IPv6 Mesh over Bluetooth(R) Low Energy using IPSP

draft-ietf-6lo-blemesh-09

Status (II/II)

- Fig. 2:

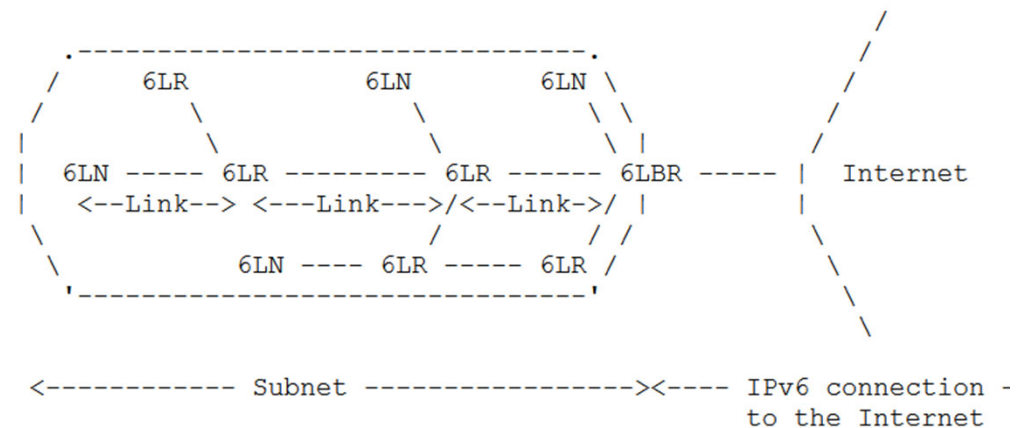
- Robert Wilton

- Remove subnet bubble
 - Top left node: a 6LR?
